World Forum for Harmonization of Vehicle Regulations

Working Party on Passive Safety

Regulation No. 94 (Frontal collision)

Proposal for 02 series of amendments to Regulation No. 94

Figure 1: Measurement of V_b , V_1 , V_2 , V_3

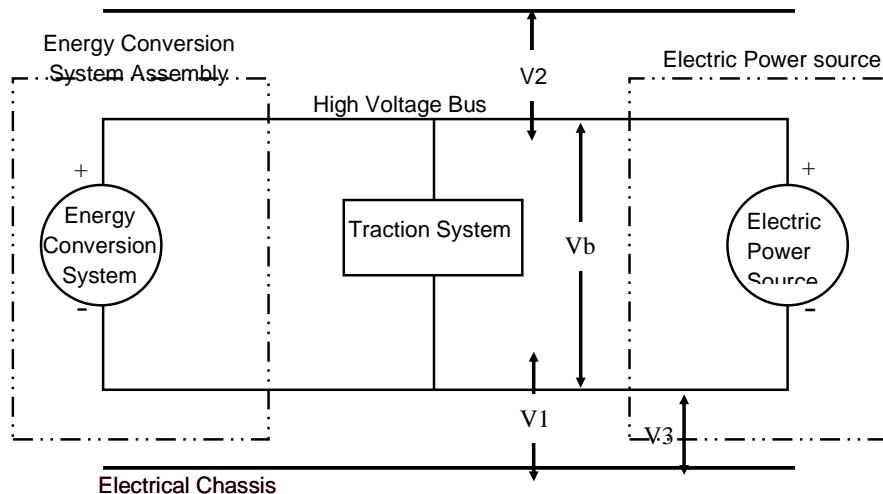
Before the vehicle crash test, measure and record the high voltage bus voltage (V_b) (see figure 1) and confirm that it is within the operating voltage of the vehicle as defined by the manufacturer.

After the crash test, determine the high voltage bus voltages (V_b , V_1 , V_2) (see figure 1). If the RESS has exposed conductive parts, measure the voltage V_3 between any exposed conductive parts of it and the electrical chassis.

[The measurement shall be made at 5 seconds after the impact].

Figure 2: Measurement of high voltage bus energy

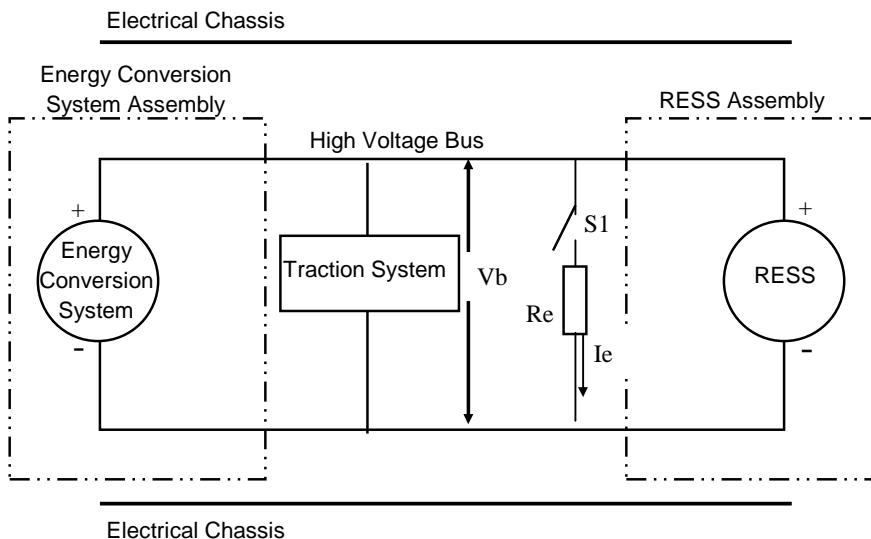
Prior to the impact a switch S1 and a known discharge resistor Re is installed according to figure 2. [At 5 seconds] after the impact the switch S1 is closed while the voltage Vb and the current Ie is measured and recorded. The product of the voltage Vb and the current Ie is integrated over the period of time starting from the moment when the switch S1 is closed (t_c) until the voltage Vb falls below the high voltage threshold of 30 V AC or 60 V DC (t_h), resulting in the total energy (TE) in joules.

$$TE = \int_{t_c}^{t_h} V_b \times I_e dt$$

Figure 3: Measurement of V_1'

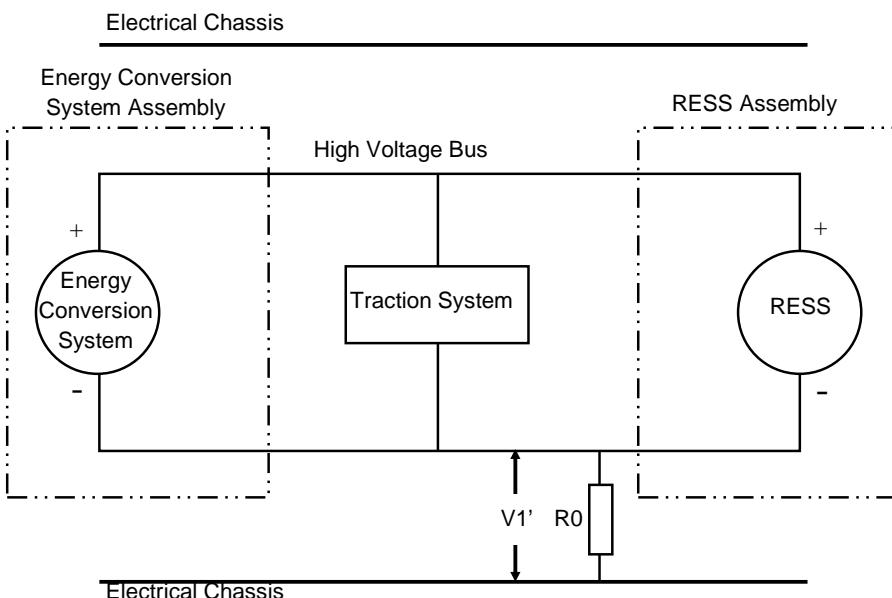
If V_1 is greater than or equal to V_2 , insert a standard known resistance (R_o) between the negative side of the high voltage bus and the electrical chassis. With R_o installed, measure the voltage (V_1') between the negative side of the high voltage bus and the vehicle electrical chassis (see figure 3). Calculate the isolation resistance (R_i) according to the formula shown. Divide this electrical isolation resistance value (in Ω) by the working voltage of the high voltage bus (in volts).

$$R_i = R_o * (V_b/V_1' - V_b/V_1) \text{ or } R_i = R_o * V_b * (1/V_1' - 1/V_1)$$

Figure 4: Measurement of V_{2'}

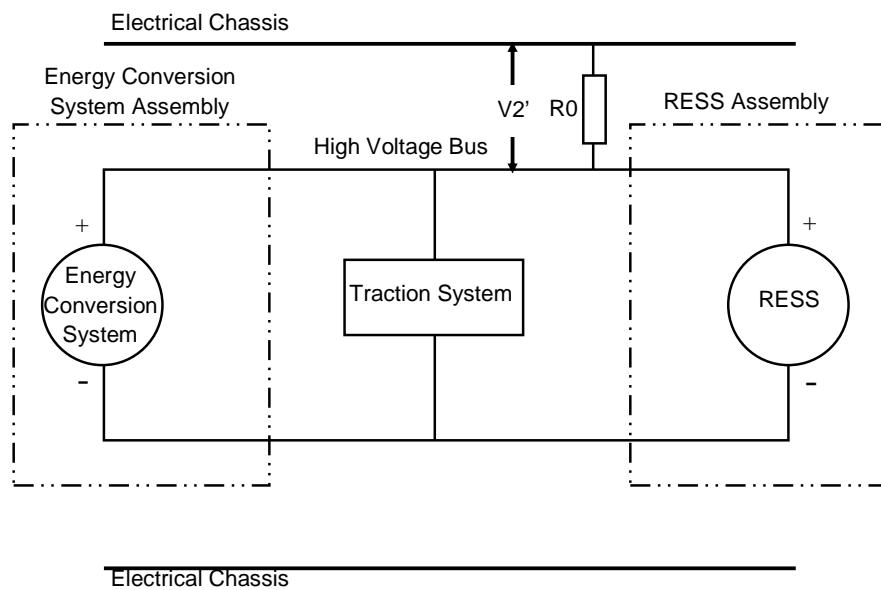
If V₂ is greater than V₁, insert a standard known resistance (R₀) between the positive side of the high voltage bus and the electrical chassis. With R₀ installed, measure the voltage (V_{2'}) between the positive side of the high voltage bus and the electrical chassis (see figure 4).

Calculate the isolation resistance (R_i) according to the formula shown. Divide this electrical isolation value (in Ω) by the working voltage of the high voltage bus (in volts).

$$R_i = R_0 * (V_b/V_{2'} - V_b/V_2) \text{ or } R_i = R_0 * V_b * (1/V_{2'} - 1/V_2)$$

Figure 1: Jointed test finger

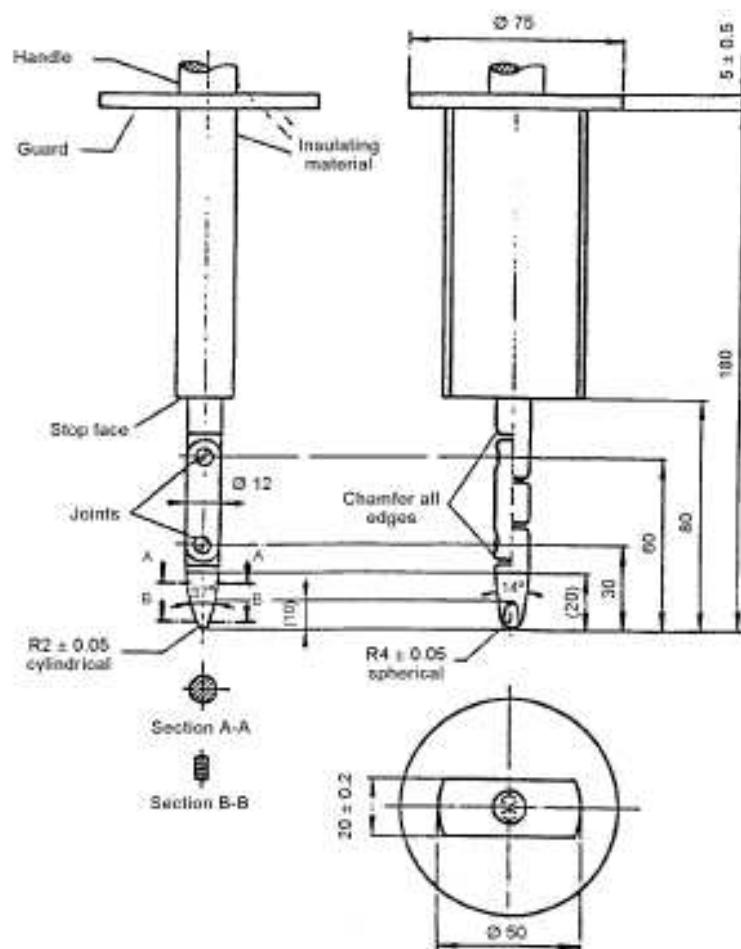
The access probe described in Appendix 1 figure 1 is pushed against any openings of the [original] physical protection with the test force of $10\text{ N} \pm 10$ per cent. If it partly or fully penetrates into the original physical protection, it is placed in every possible position.

Starting from the straight position, both joints of the test finger shall be successively bent through an angle of up to 90 degree with respect to the axis of the adjoining section of the finger and shall be placed in every possible position.

In the case of the test for IPXXB, the jointed test finger may penetrate to its 80 mm length, but the stop face (diameter 50 mm x 20 mm) shall not pass through the opening. Starting from the straight position, both joints of the test finger shall be successively bent through an angle of up to 90 degree with respect to the axis of the adjoining section of the finger and shall be placed in every possible position.

Both joints shall permit movement in the same plane and the same direction through an angle of 90° with a 0 to +10° tolerance.”
